4092519

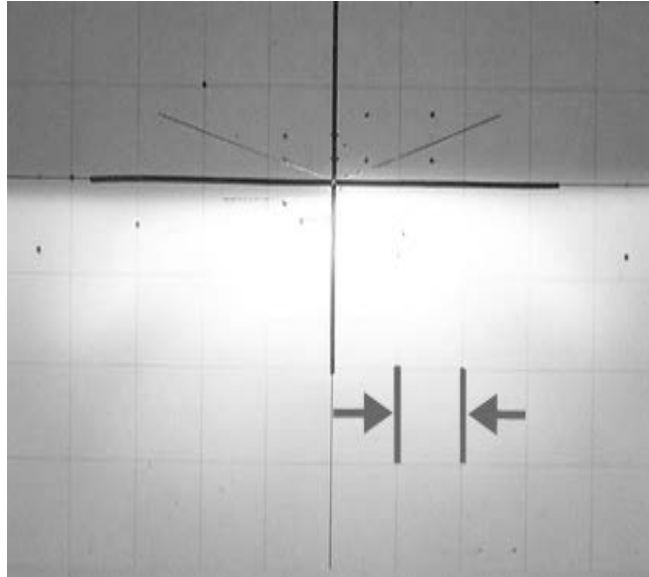
Important: When installing the new headlight bulbs, do not touch the glass and pay close attention that the bulbs are fully seated into the headlight housing. If the bulb is not properly installed it can lead to an incorrect light pattern. A beam pattern photo with a properly installed bulb is shown below. This photo is of a GMC Sierra Low beam pattern (1 Lamp with opposite lamp blocked) on wall/aiming screen at 25 ft (7.62 m). Each block division is approximately 10.5" (26.67cm)

4092121

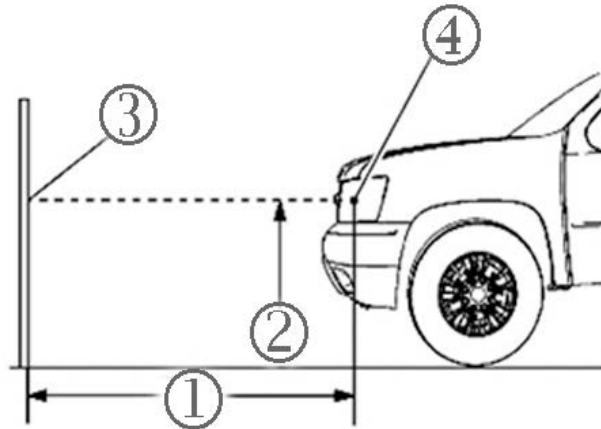
1. 25 ft (7.62 m)
2. Height of Horizontal Aiming Line on screen
3. Aiming Screen or Wall
4. Reference mark (small circle) on headlamp lens
9. Turn the headlamps ON.
10. Block the light from projecting onto the screen from the passenger side headlamp. This will allow the cutoff ("top" of the beam pattern) in the beam pattern from the driver's side to be more pronounced for easier aim verification.

4092365

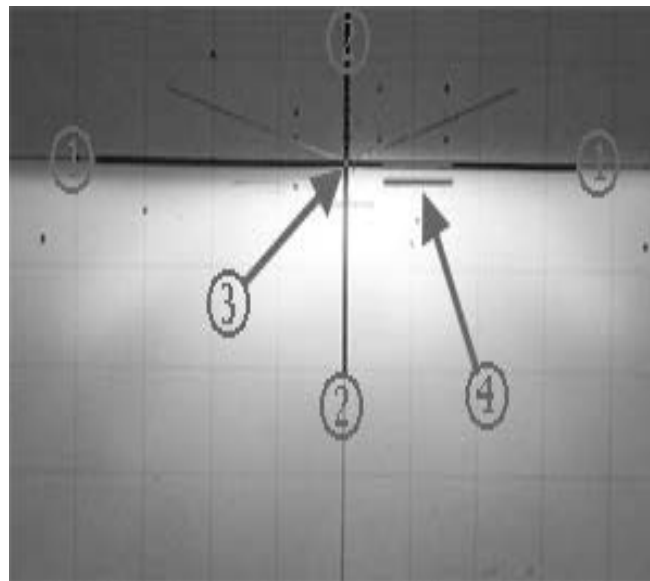
11. On this vehicle you will be verifying the vertical aim of the cutoff (top of the beam pattern) on the right side of the "step" in the beam pattern.
12. If the vertical location of the cutoff projected onto the screen or wall differs from the figure below, then an adjustment to the beam pattern location is necessary.

1. Horizontal Aiming Line
2. Reference line only, Not needed for proper aiming
3. Step in beam pattern
4. Top of beam pattern (cutoff line) positioned at the horizontal aiming line +0 / -0.75" (-19mm)

13. Adjust the vertical headlamp aim adjustment screw until the cutoff (top of the beam pattern) on the right side of the beam pattern step is set between the Horizontal Aim Line and 0.75 (19mm) inches below.
14. Repeat the aiming procedure for the passenger's side headlamp while blocking the light from projecting onto the screen from the driver's side headlamp.
